Comments and Response Report

The Proposed Construction of an Access Road, Residential Dwelling on Portion 76 of the Farm 216 Uitzicht, Brenton, Knysna

COMMENTS	RESPONSE
COMMENTS RECEIVED IN RESPONSE TO THE DRAFT BASIC ASSESSMENT REPORT – 3 September 2020 to 3 October 2020	
STATE DEPARTMENTS	
Forestry, Fisheries & The Environment (DFFE) – Melanie Koen – 30 September 2020

Site Development Plan road

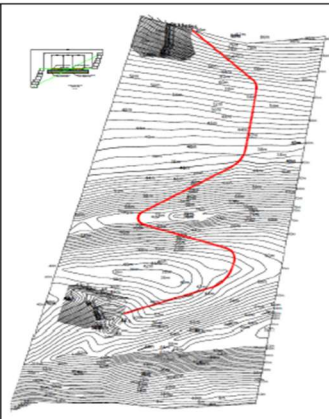
The road is proposed over 2 pristine dunes

Post fire Knysna Sand Fynbos in very good condition

Noted.

Proposed Site Development Plan with main house, road and managers cottage.

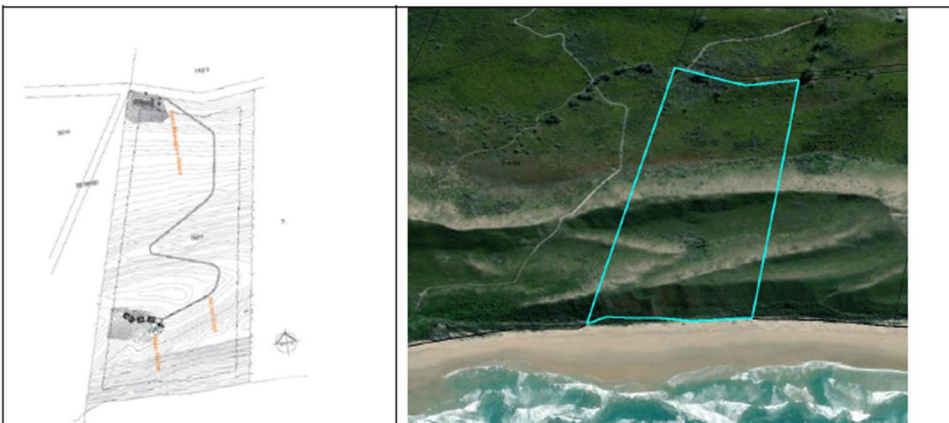
The proposed option to use the Campbell road will reduce the negative impact on biodiversity but will necessitate a new section of road to be constructed on the Campbell property and over Portion 76.

Noted. The preferred development plan has been amended to exclude the construction of a farm manager's residence in the northwestern corner of the property.

Figure 3 – Architectural plan of the proposed main dwelling

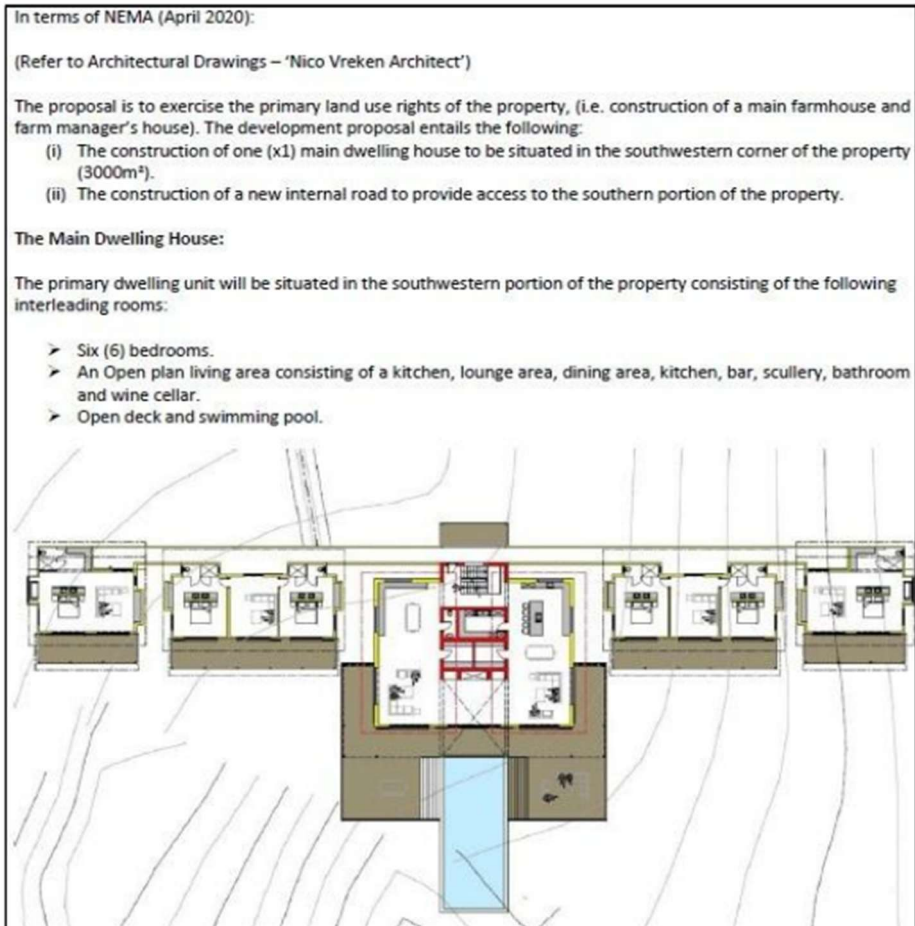
Only a basic floor plan of the preferred main dwelling proposed for the south-western corner of the site has been submitted for consideration (see Fig. 3 below), despite a reference to other architectural drawings. However,

there are no details pertaining to elevations, sections, 3D views, floor levels, or any external views from different angles. Reference is made to the approximately 3,000 m² disturbance area, without clarifying how much of this is building footprint, disturbance during construction, parking areas, water storage, utility areas sewerage disposal facilities, topsoil storage areas and so on. The floor plan in Fig. 3 has no scale and we can only guess that the main dwelling appears to be approximately 55m long and could be double or even triple storey.

located in the south-western corner—has been provided at this stage, as the project is still in the environmental assessment phase. Full architectural details, including elevations, sections, and 3D views, will be submitted with the formal land use application to the Knysna Municipality, in line with statutory requirements and public participation.

Figure 5 – The vegetation of Uitzicht 76

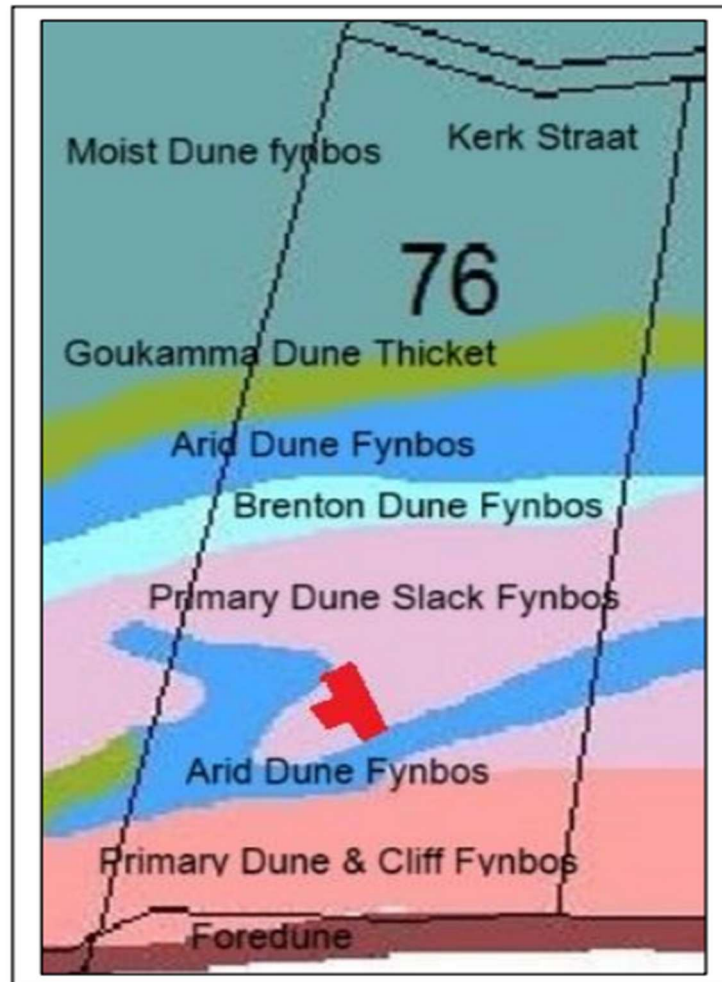
The Plant Species and Terrestrial Biodiversity Assessment (Fouché 2024) looked at the SANBI vegetation types (VEGMAP, 2018) but also at Vlok's vegetation types (2005) which are on a finer scale (see Fig. 5). Knysna Sand Fynbos (FFd10) is equivalent to Vlok's "Moist Dune Fynbos", which is south facing and moderately steep in places. Goukamma Dune Thicket (AT36), which Mucina & Rutherford had named South Cape Dune Fynbos (FFd11) in 2006, is only present as a thin strip in Vlok's vegetation mapping, found at the bottom of the primary dune. Higher up the dune this becomes Arid Dune Fynbos, which is north facing, very steep and sandy near the summit, and erodes easily if the vegetation is removed. The proposed "internal road" has to overcome this substantial obstacle. After the top of the dune it descends into south facing and gently sloping Brenton Dune Fynbos (BDF), a very rare vegetation sub-type poorly represented in the Goukamma Nature Reserve (GNR). In the shallow valley Primary Dune Slack Fynbos occurs, which is only found on the Brenton dunes and even scarcer than BDF. On this incredibly rare vegetation the applicant wants to build a 3000 m² dwelling, which will be high enough to be seen from Buffalo Bay behind the highest primary

Fouché (2024) found that the vegetation now mapped as Goukamma Dune Thicket contains a number of Red List plants and has a HIGH sensitivity ecologically. From an environmental perspective it would be difficult to find a place less suited to building a house.

6. SITE SENSITIVITY VERIFICATION 6.1 Terrestrial Biodiversity The sensitivity of the terrestrial biodiversity theme for the site is confirmed as Very High as the site contains a significant area of remaining natural vegetation of a CR vegetation type (Knysna Sand Fynbos) north of the large barrier dune on the site, which is threatened by invasive plants, especially pines. The southern section of the site is also sensitive habitat, characterised by a strandveld-fynbos mosaic with thicket patches in fire refugia on the site (i.e., the dune slacks, and some sections on the dune crests). Furthermore the whole site is a CBA1, and forms part of an area that served an important corridor function along the coastline. 6.2 Botanical diversity The site sensitivity in terms of the terrestrial plant species theme is confirmed as High, as the site is home to several SCC, and there is some spatial heterogeneity over the site in terms of the distribution of the SCC found. These High and Very High sensitivities mean that is of critical importance to minimise the disturbance area of all activities during construction and operations, and in fact it would be best to not disturb the southern part of Uitzicht 76 at all.	While complete avoidance of the area is not feasible given the integrated planning constraints, the development will be implemented with site-specific mitigation, clustered design, and strict environmental controls, consistent with the recommendations of the specialist assessments.

Figure 5 – The three alternatives assessed in the DBAR – Alternative 4, the least environmentally damaging, was not considered

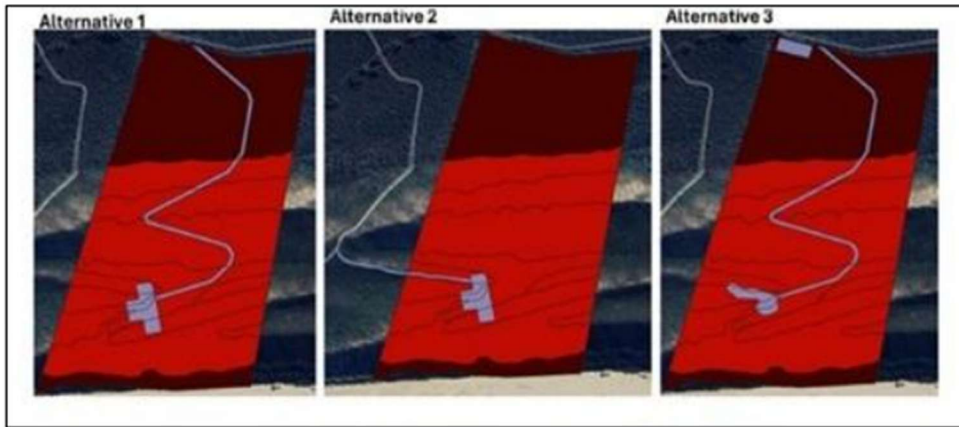
The DBAR Illogically selects the worst two Alternatives (1 & 3 ref BAR page 76) contrary to the conclusion that Alternative 4 is the best as per Page 77 and ignores the fact that an internal road is not allowed under the WCLUPGRA 2019 guidelines pertaining to Core 1 SPC. The applicant needs to be interrogated as to why Alternative 4 (Fig. 6) is not being considered, and Alternative 1 is the preferred option.

Fig. 2. Approximation of disturbance of foredune by proposed access road and dwelling (Source: SANParks).

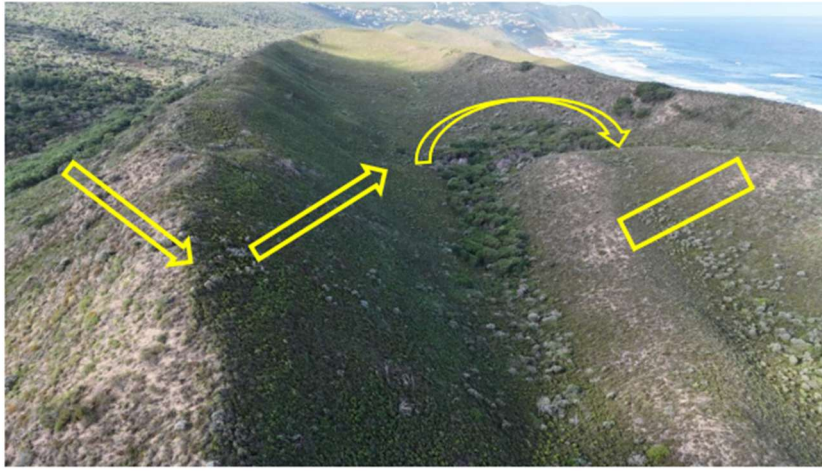
Further, **Fig. 4** illustrates that the proposed road access to the dwelling over the foredunes will traverse two steep slope areas, i.e., going up and over the dune where slopes are $>30\%$. The northern slope of this dune is sparsely vegetated due to a north facing aspect, erosion on this slope is highly likely. Embankments and retaining structures will be necessary, which will increase disturbance footprint areas, and loss of vegetation.

Figure 4 – Road construction details from Appendix D12 Civil Services Report

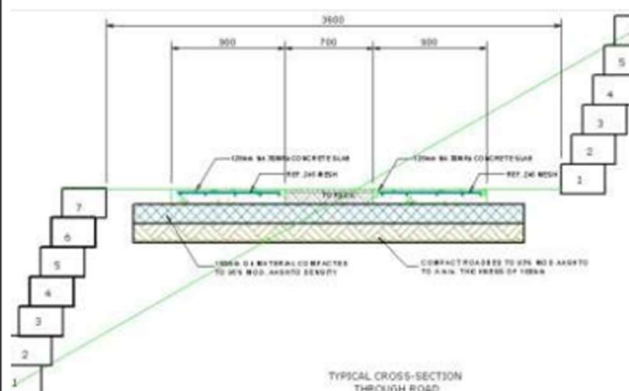
- Reinforced concrete strip roads (Fig. 4 above) are environmentally harmful, and except on steep slopes the internal road should be built of natural materials like the road on Uitzicht 216/39.

• Will this internal road be sufficiently strong and wide enough to support heavy construction equipment which has a large turning circle? • The internal road traverses a steep second primary dune with a >50% gradient to reach the main dwelling in the southwest part of the property. Appendix D12 Civil Services Report (p. 13) shows the volume of soil to be removed & added. Fig. 4 also shows the ground stabilising blocks needed due to the extreme gradient of the road over the second primary dune. • There is no consideration of the impact of an estimated 4 000 ton topsoil excavation (Appendix D12 Civil Services Report) during road construction. The majority of this soil needs to be removed and some potentially stored for back fill. This 4 000 ton or 2282 m³ of soil will require over 400 loads of 10 ton trucks that hold a high environmental risk component. It will also place huge pressure on the farm road which is the only access to the site (see Fig. 4 “the dirt track along the road reserve will need to be upgraded”). • Amongst the environmental impacts of the proposed internal road even after it is built will be: - o disruption & fragmentation of the vital east-west ecological corridor for animals - o stimulation of alien plant growth in the disturbance area - o roadkill of animals from heavy vehicle traffic during construction and later passage of clients to and from what appears to be a “boutique hotel” on the primary dune	operation of the access road are included in the Environmental Management Programme (EMPr). Noted. The comment has been considered. The detailed engineering design of the proposed access road, including its structural capacity, width and turning requirements for construction vehicles, will be addressed during the detailed design phase by the appointed professional engineers. The Final Basic Assessment Report assesses the environmental implications of the proposed development at the level of detail required for a Basic Assessment. Noted. The comment has been considered. The Final Basic Assessment Report reflects the engineering and geotechnical information relating to the proposed access road, including the anticipated earthworks and associated stabilisation requirements. These considerations have been incorporated into the environmental assessment and informed the comparative assessment of reasonable alternatives. Noted. The comment has been considered. Construction activities, including earthworks, excavation, transportation of material and construction-related vehicle movements, have been assessed in the Final Basic Assessment Report. Appropriate mitigation measures relating to construction traffic, erosion control, dust suppression, material handling and site management have been incorporated into the Environmental Management Programme (EMPr). Noted. The comment has been considered. The potential ecological impacts associated with the proposed internal access road, including habitat fragmentation, disturbance to fauna and flora, and the potential establishment of invasive alien vegetation, have been considered in the Final Basic Assessment Report and informed the impact assessment, comparative
